- a. A request from Stanton Furniture for a Site and Design Review to construct a 167,000 square foot manufacturing and distribution facility at the corner of SE 4th Ave and S Mulino Rd. (DR 19-03)

## **STANTON FURNITURE DR 19-03**

File #: DR 19-03 – Stanton Company - Pacific Furniture

**HEARING DATE:** January 27, 2020

SOUTH ELEVATION  
A2.0  
3/64" = 1'-0"  
ELEVATION S

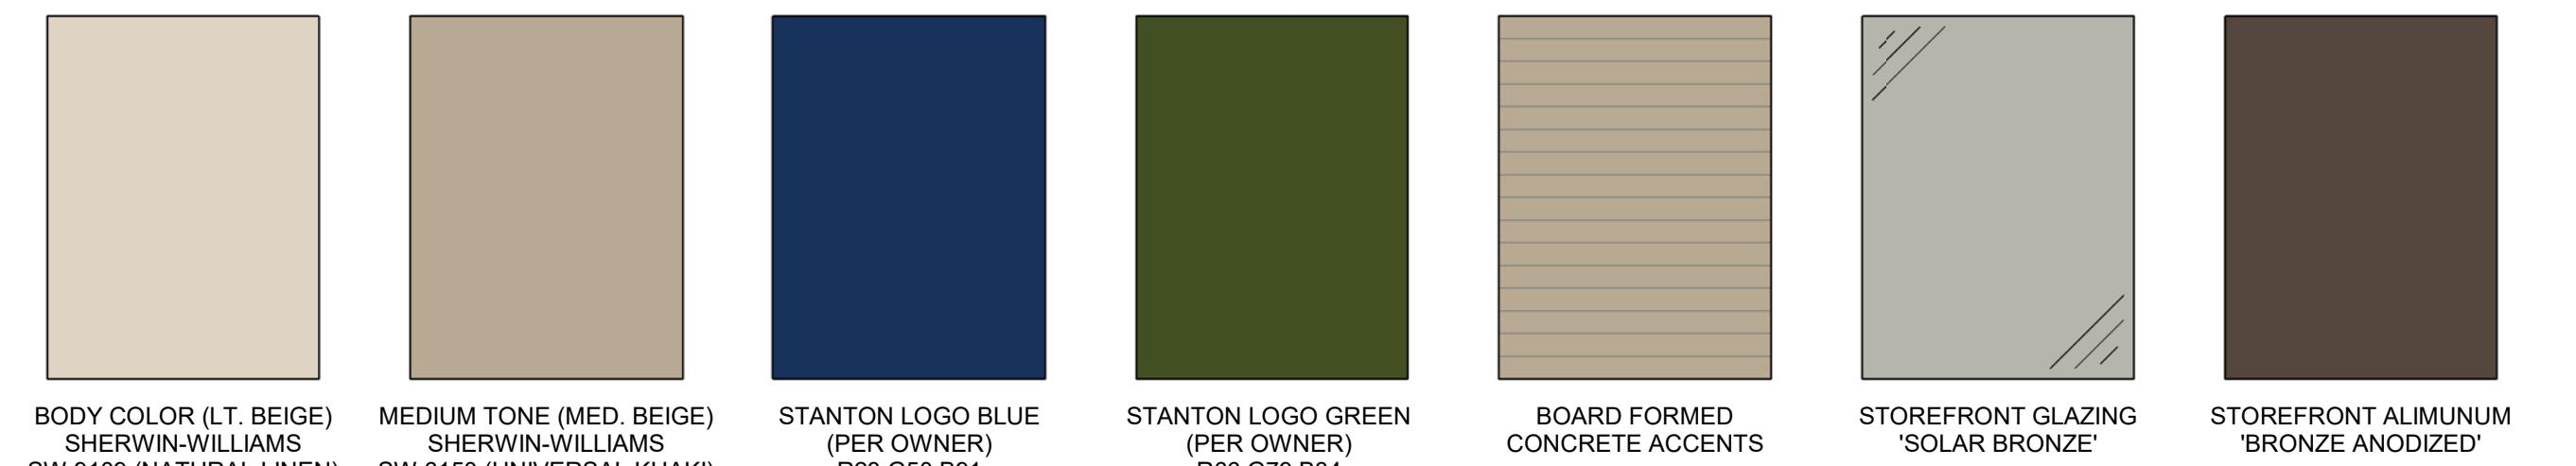
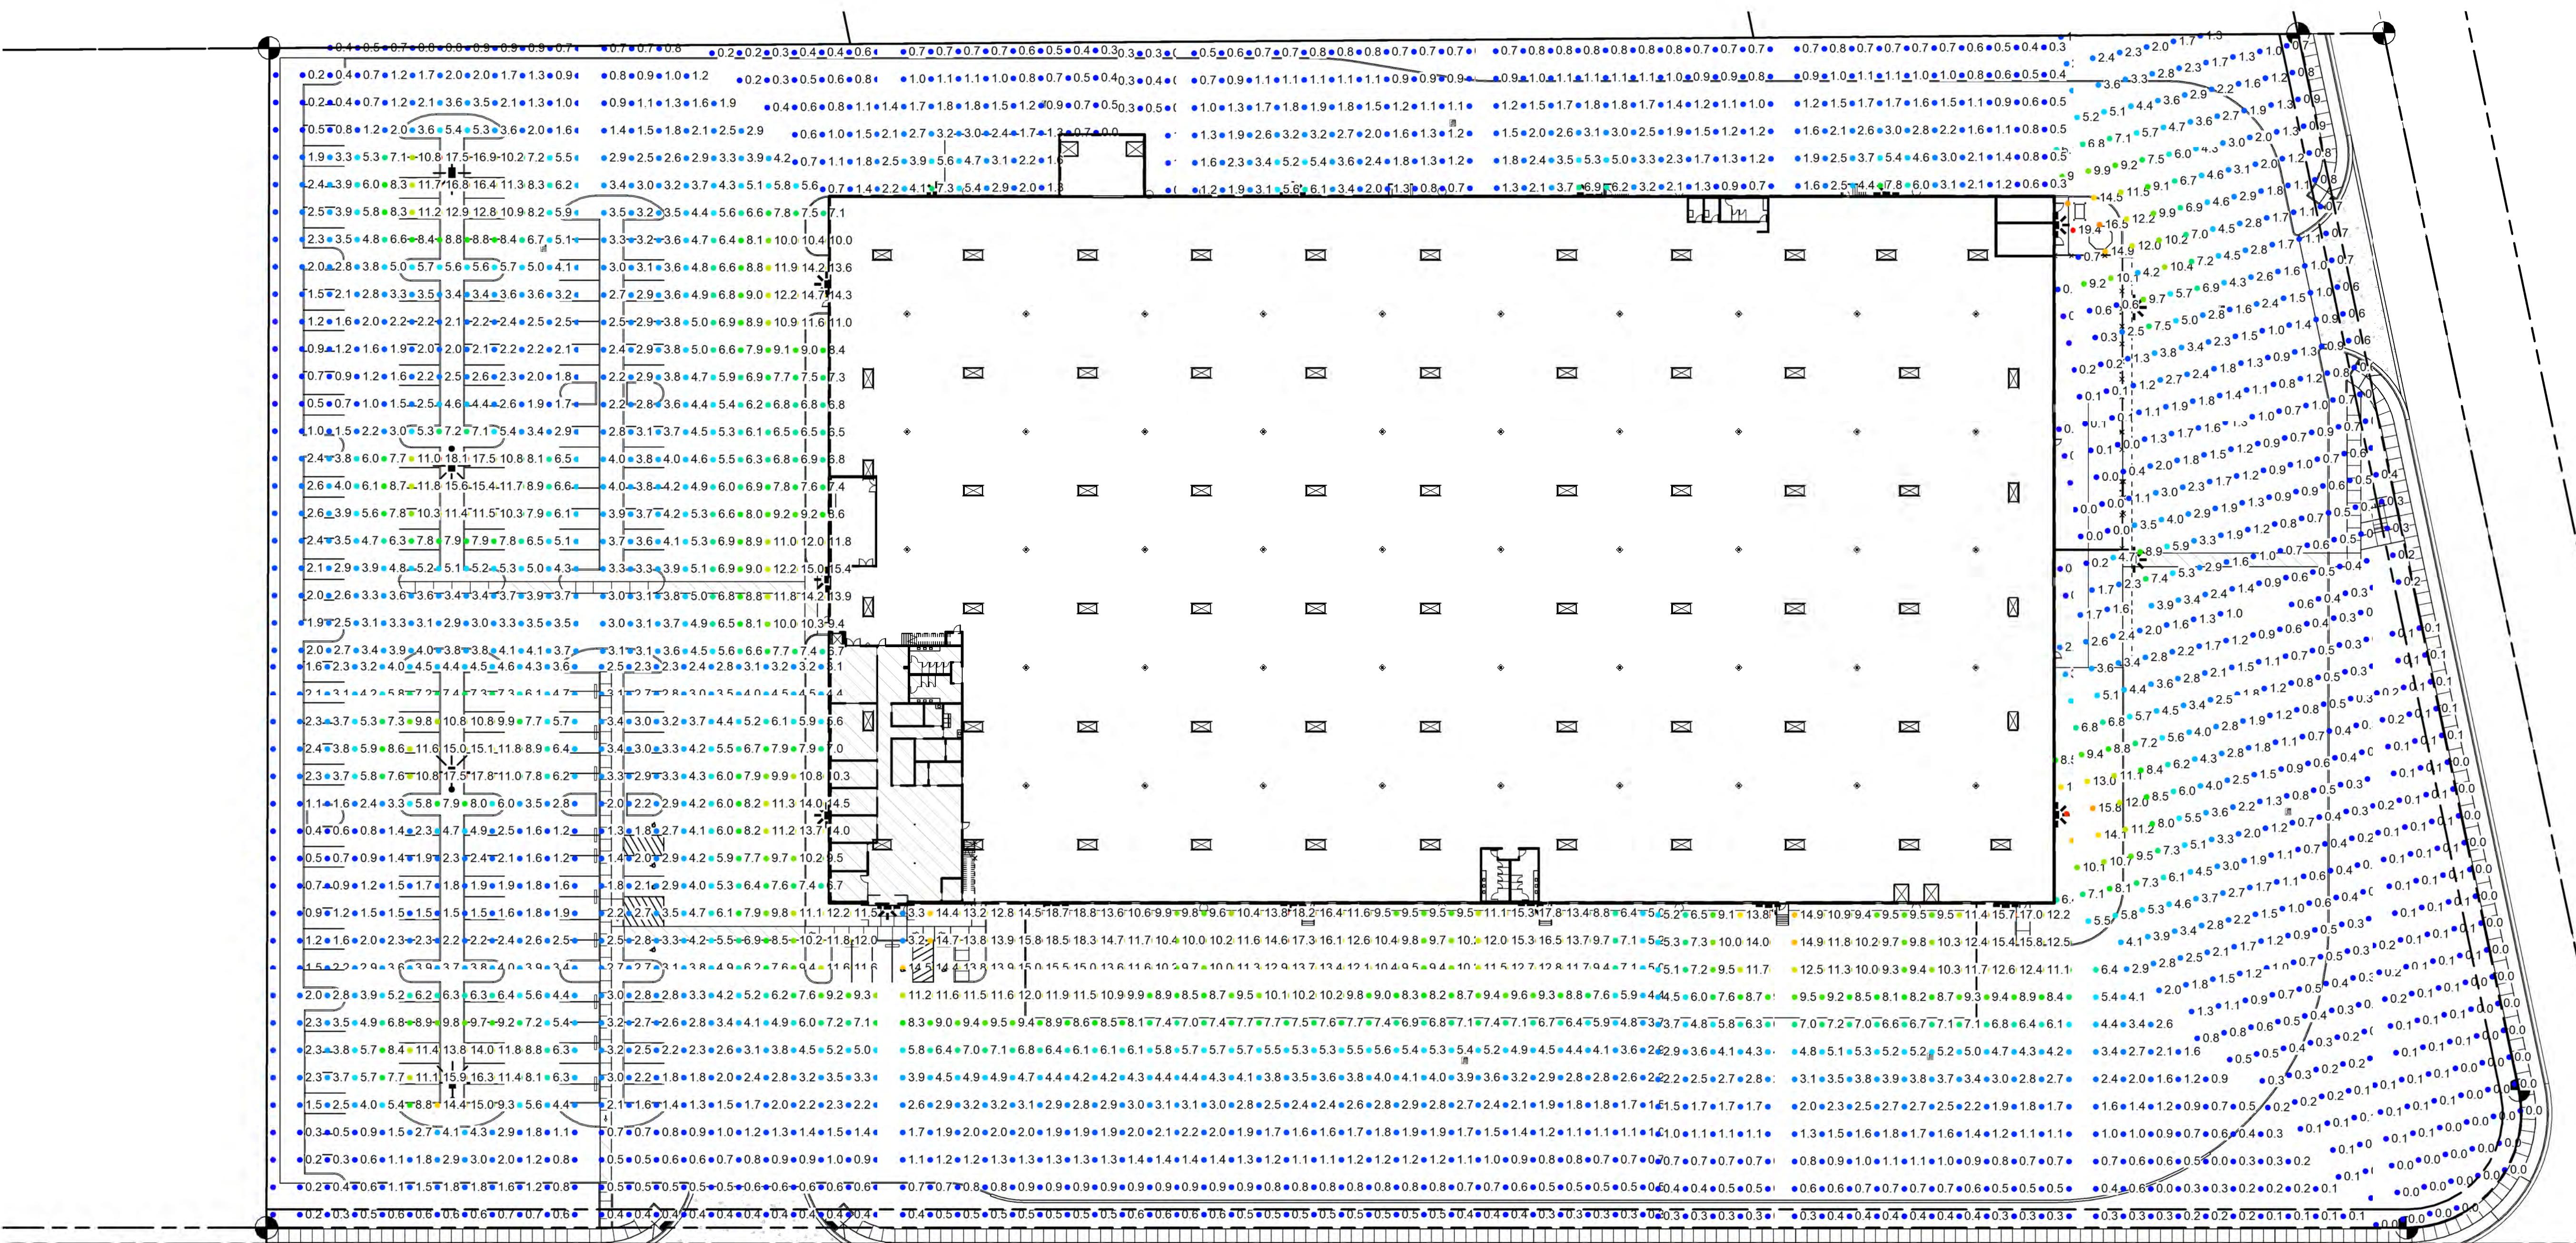
The applicant proposes tilt-up concrete construction. The building will be articulated with a variety of concrete panel designs and colors in order to provide visual differentiation on the south and east elevations. Per Sheet A2.0, *Building Elevations*, of the submitted Site Plans, there will be accent colors near the office area of the building providing visual relief. The Stanton logo will be a blue and deep olive-green color, in addition to other horizontal concrete accents between windows (glazing).
